# UNITED STATES PATENT AND TRADEMARK OFFICE

APPLICATION NO.	FILING DATE	FIRST NAMED INVENTOR	ATTORNEY DOCKET NO.	CONFIRMATION NO.
09/994,903	11/28/2001	Hideaki Maeda	1417-371	7361

# Office Action Summary

## DETAILED ACTION

**FIG. 1**

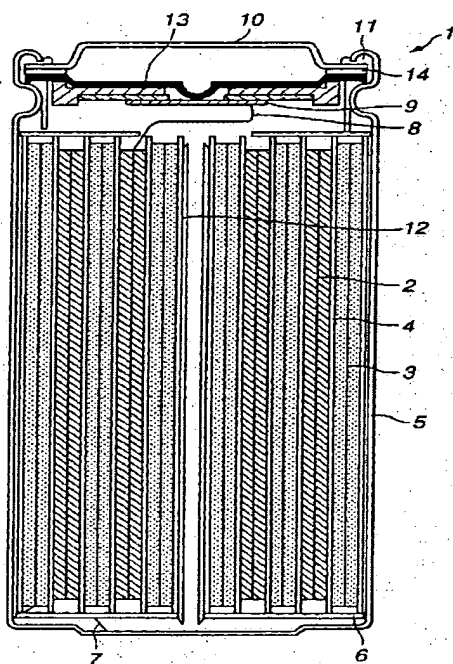
As for claim 10:

Figure 1 below shows the battery comprising an anode, a cathode, a separator, an electrolyte therein.

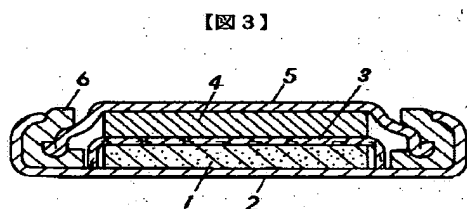
As for claim 10:

Figure 3 below shows the battery comprising an anode, a cathode, a separator, an electrolyte therein.
